# **ODSCC ARC Submittal for Watts Bar Nuclear Plant**

**Tennessee Valley Authority  
Watts Bar Nuclear Plant  
NRC Meeting  
7/17/01**

# Answer to Outstanding RAIs

# Figure 1: STP Model

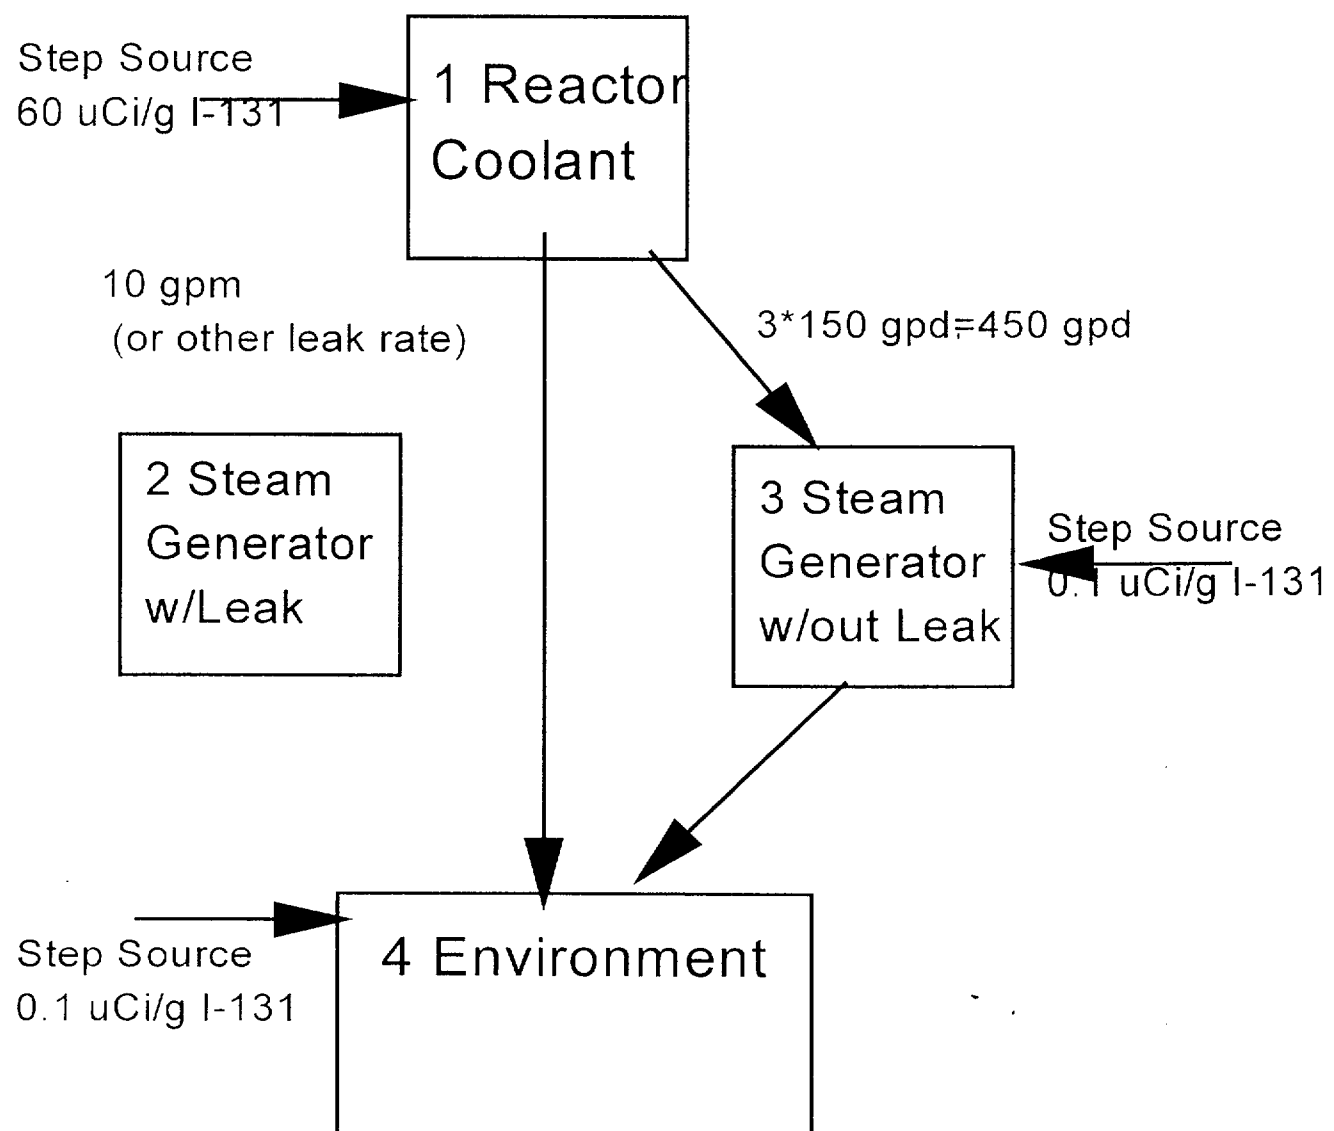
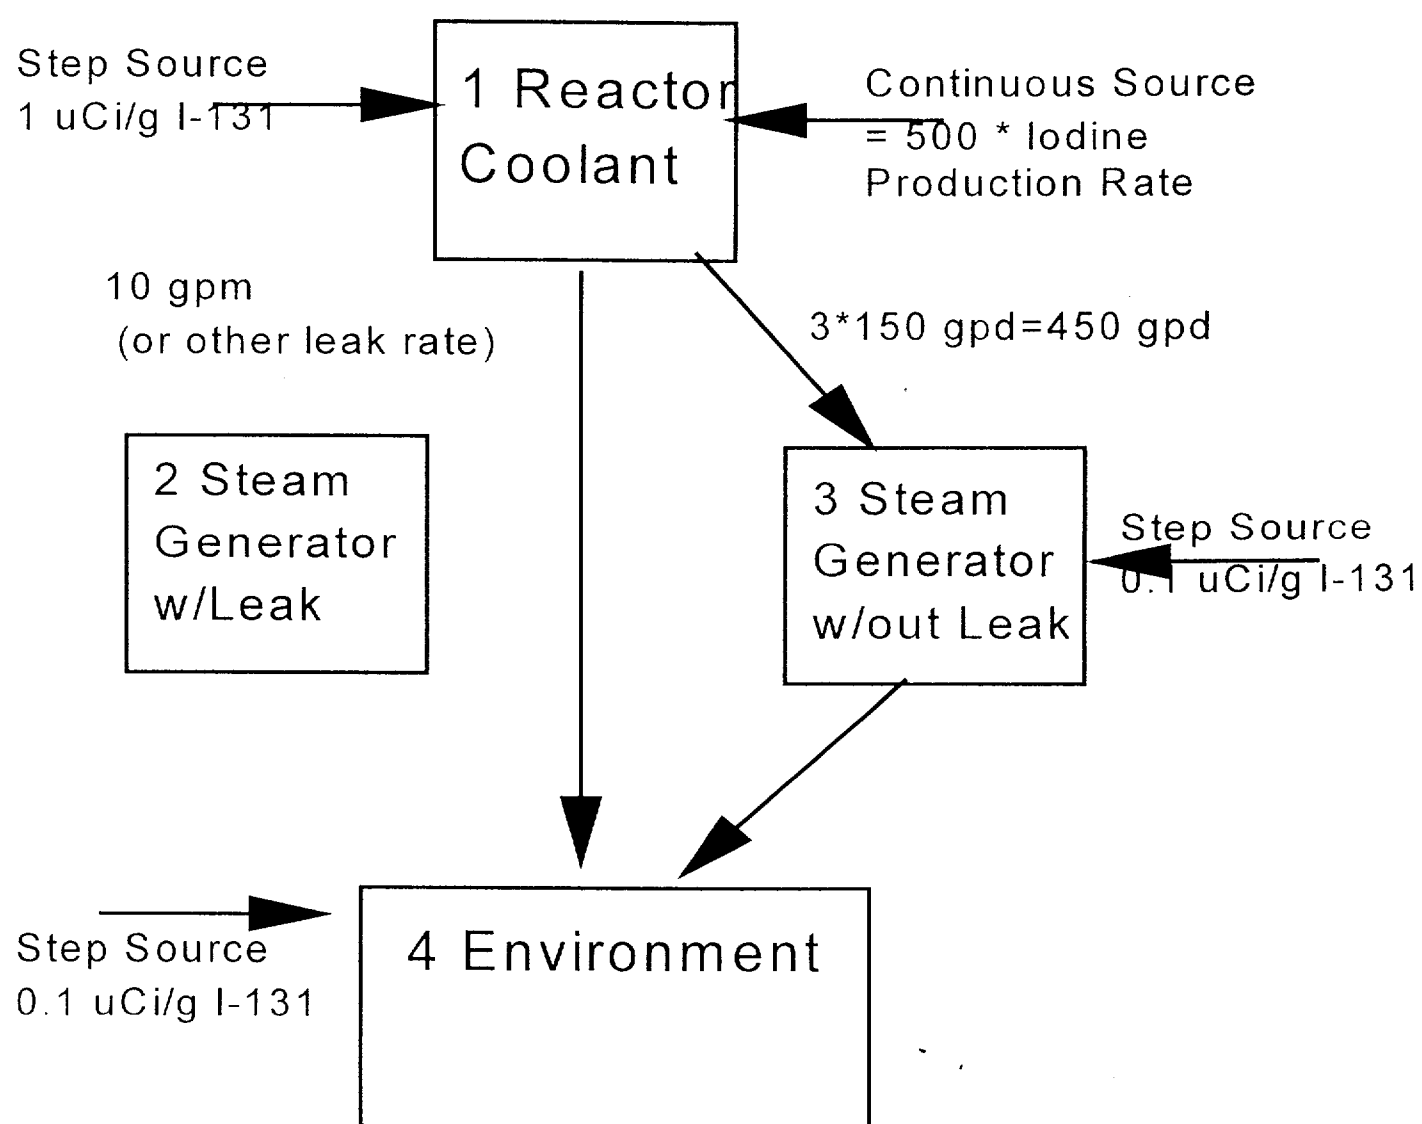
- **Flows of 150,000 lb and 2509 lb should be considered separately since the 150,000 lb is secondary side at 0.1 uCi/gm and the 2509 lb is primary side at a higher concentration.**
- **Response: Agree. The revised calculation model steps the 150,000 lb secondary side into the environment at time 0. The RCS primary side leakage is modeled separately as a flow from the RCS to the environment.**
